REMARKS

The present invention is directed to a method and apparatus for the implementation of reduced state sequence estimation that uses precomputation (look-ahead) to increase throughput, with only a linear increase in hardware complexity with respect to the look-ahead depth. The present invention limits the increase in hardware complexity by taking advantage of past decisions (or survivor symbols). The critical path of a conventional RSSE implementation is broken up into at least two smaller critical paths using pipeline registers. Various reduced state sequence estimation implementations are disclosed that employ one-step or multiple-step look-ahead techniques to process a signal received from a dispersive channel having a channel memory.

Drawings

FIG. 5

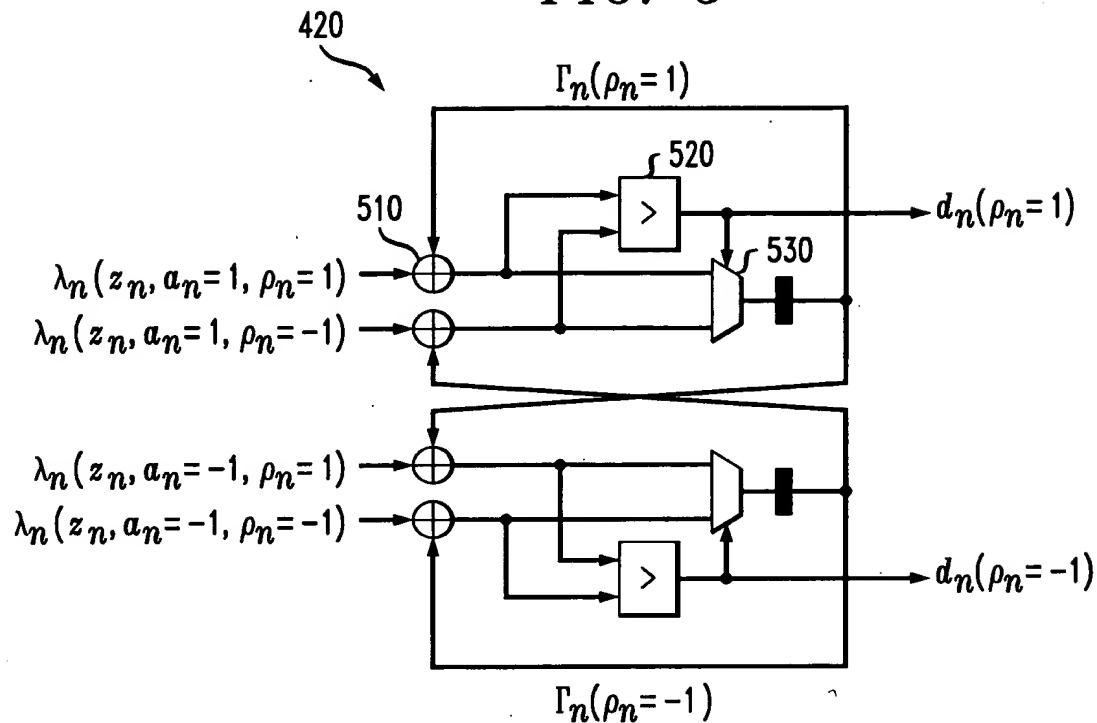
The drawings were objected to as failing to comply with 37 CFR 1.84(p)(5) because they include reference signs not mentioned in the description and because of handwriting in FIG. 14.

The drawings have been amended to delete the reference signs that were
 15 not mentioned in the description. The formal drawings are also resubmitted herewith with a FIG. 14 that does not contain handwritten text. Applicants respectfully request that the objections to the drawings be withdrawn.
